*Request for Competitive Solicitations
Rebid Sands SLR Roadway and
Drainage Pilot Project, Big Pine Key,
Monroe County, Florida
RFP-484-0-2023/la
ADDENDUM NO.5
March 20, 2023*

Questions, Responses and Clarifications:

Note: Bid sheets have been revised. Plan sheets G-8B, RD-4B, S1-B, SQ-1B, S-12B, TC-1B, TC-2B have been revised.

SHEET NO.
TC-2B

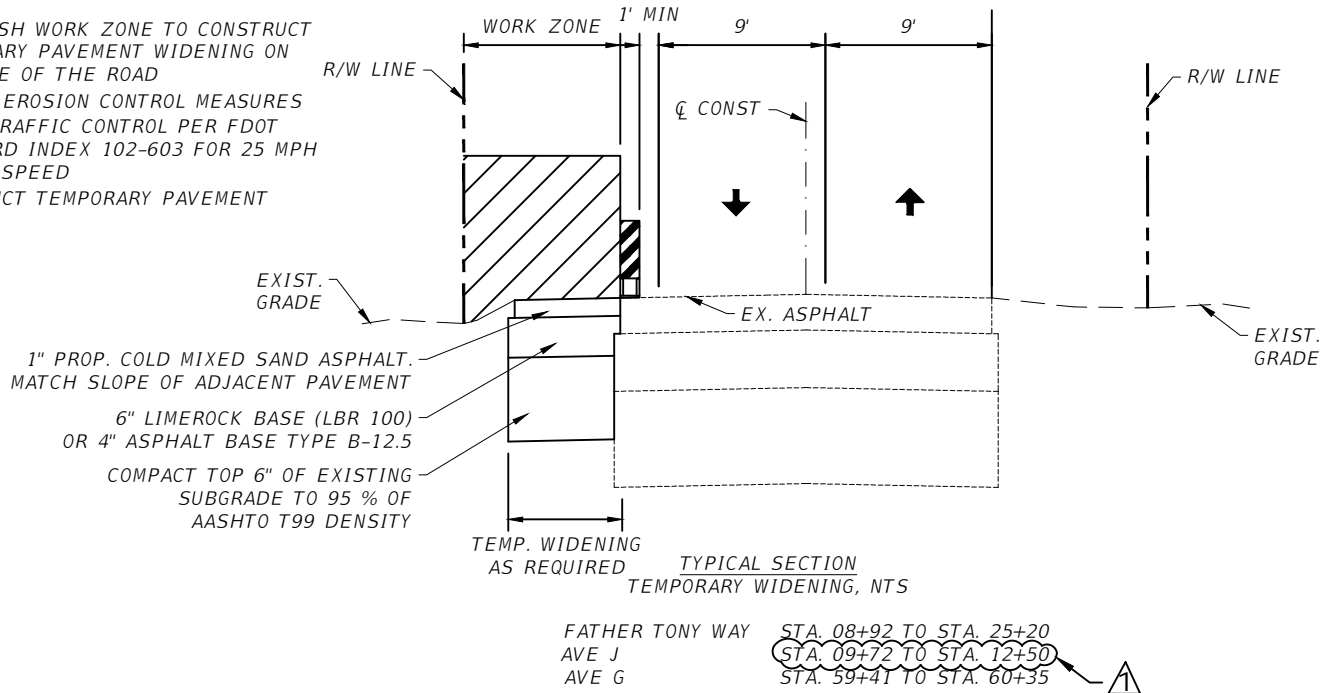
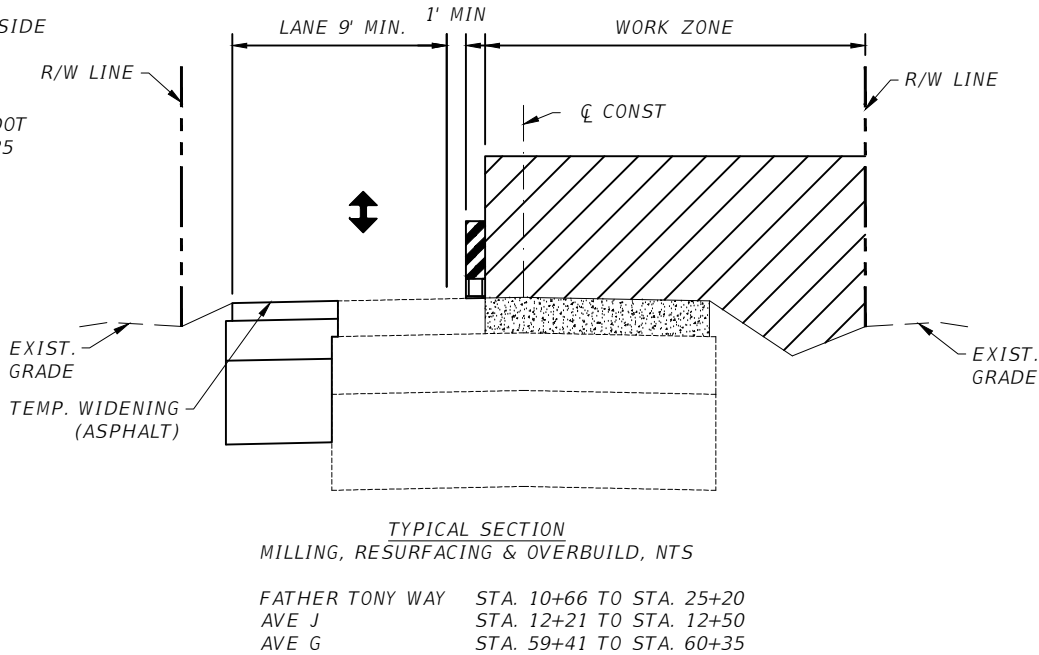
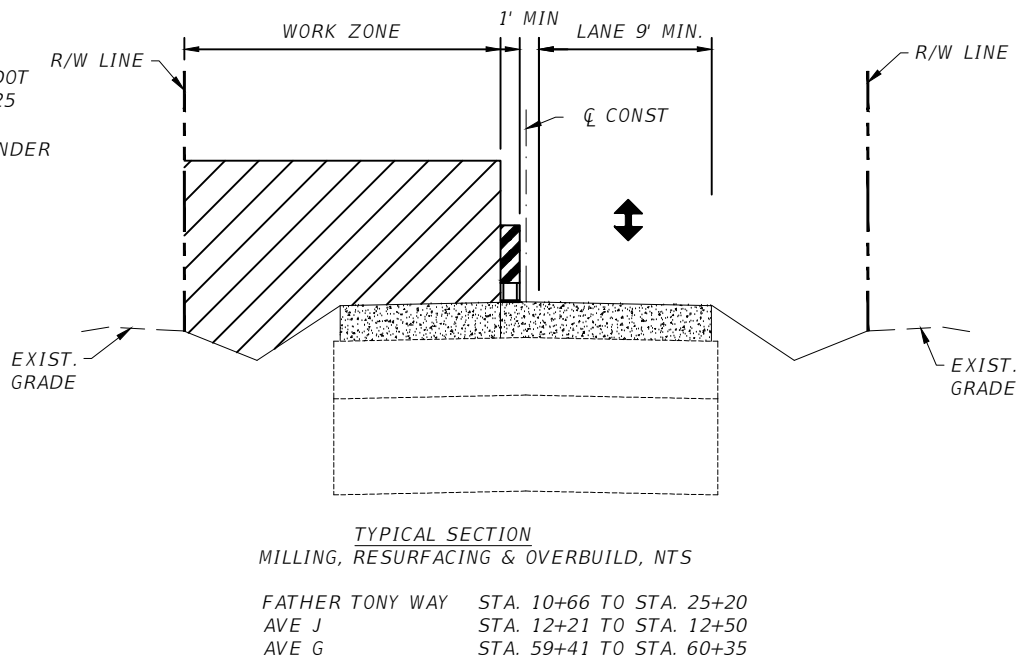
Q4: Sheet G-2B Typical Section J says that it begins at Station 9+72.1. Traffic control plan sheet only shows widening beginning at Station 9+80. Should the widening begin at Sta 9+72?

Q5: See previous question. Temporary traffic Control Plans sheet TC-2B shows a temporary widening in Pre-Stage 1 on Ave J from Sta 9+80 to Sta 12+21. In Stage 1A - we Mill, Resurface & Overbuild on Ave J from Sta 12+21 to Sta 12+50. Pre-Stage 2 shows Temp widening with gravel from Sta 9+80 to Sta 12+21 – the same as the asphalt. Believe that is not necessary, but is there no Temporary Widening from Sta 12+21 to Sta 12+50, or does the Temp Widening in Pre-Stage 1 go from 9+80 (or 9+72) to 12+50?

R4: Refer to revised plan sheet TC-2B. Begin at 9+72. Stationing label has been revised on sheet TC-2B.
